**TOWN OF NEWBURGH  
PLANNING BOARD  
TECHNICAL REVIEW COMMENTS**

**PROJECT NAME:** OVERLOOK FARMS  
**PROJECT NO.:** 19-23  
**PROJECT LOCATION:** SECTION 9, BLOCK 1, LOTS 10, 11,12, 56.21 & 56.22  
**REVIEW DATE:** 27 JANUARY 2023  
**MEETING DATE:** 2 FEBRUARY 2023  
**PROJECT REPRESENTATIVE:** ENGINEERING AND SURVERYING PROPERTIES

RE: JMC Project 17088  
 Overlook Farms a Farrell Community  
 5417 Route 9W  
 Town of Newburgh, NY

**INT. 5 - ROUTE 9W & SITE DRIVEWAY INTERSECTION SIGHT DISTANCE**  
(1" = 60')

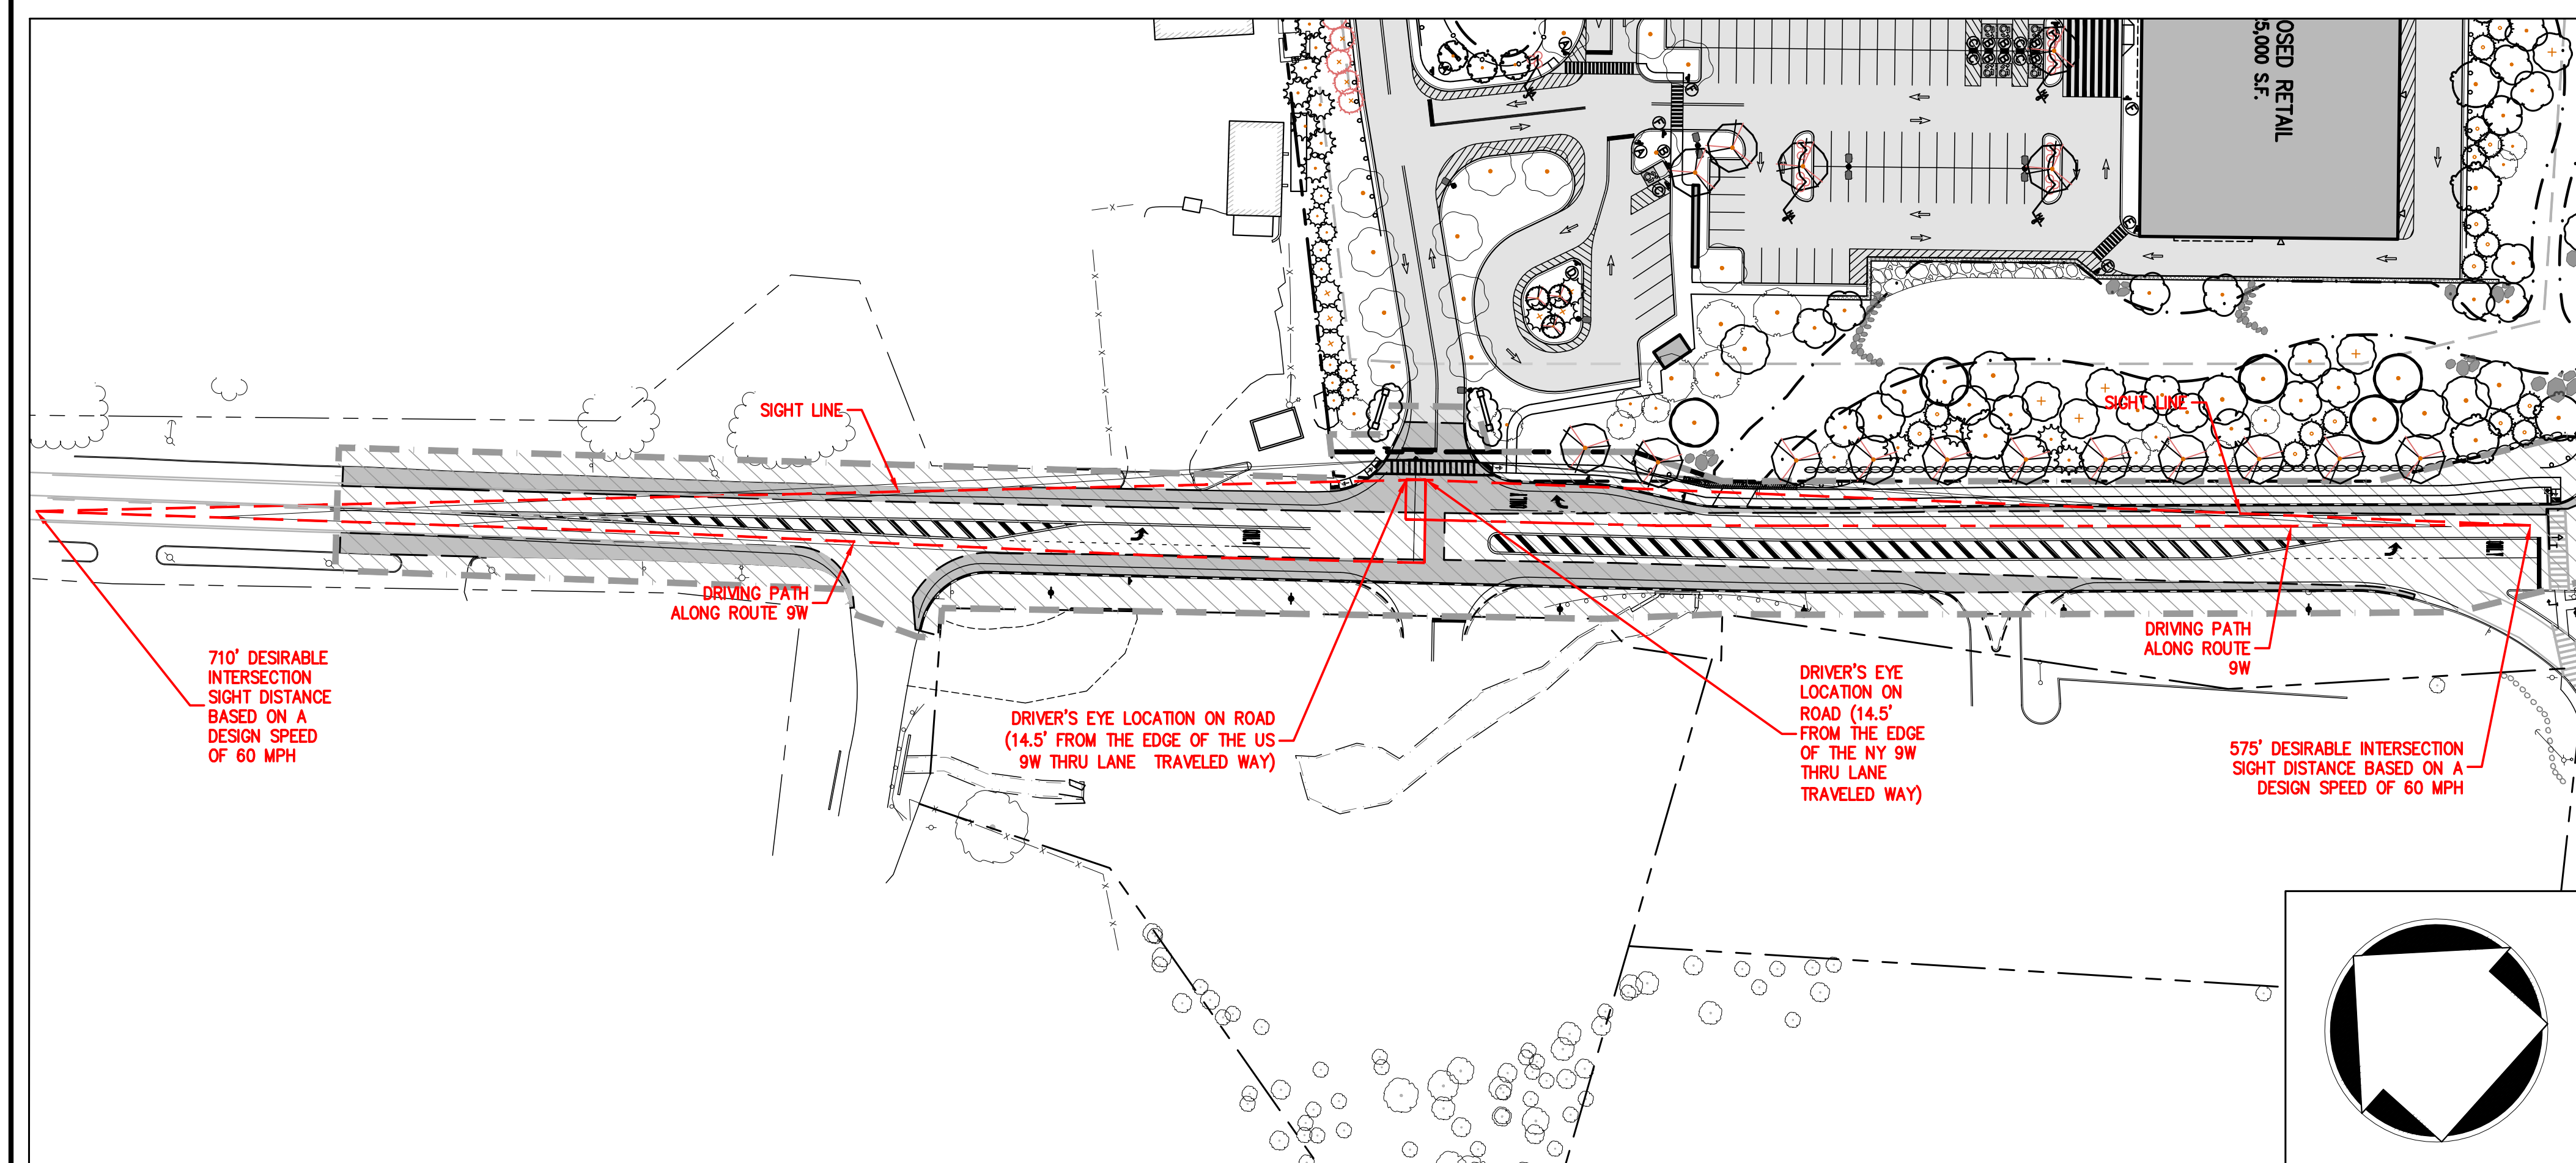
*The applicant responded to our June 10th comment letter with a revised entrance detailing the NYSDOT changes and our suggestion for a new intersection configuration between the apartments and the retail use. An excerpt is attached. Placement of the pylon signs should be verified to not limit sight distance. Not knowing their design, we suggest moving the residential monument sign about 20 feet further up Road A, in front of the infiltration basis. The pylons at the Route 9W entrance should also move back some more to allow better views without a vehicle having to block the cross walk.*

The locations of the signs have been adjusted as requested. As shown on Drawing C-520 "Sight Distance Analysis Plan", the proposed signs along US 9W are located outside of the intersection sight distance triangles. Additionally, the signs are located approximately 15.5 feet back from the
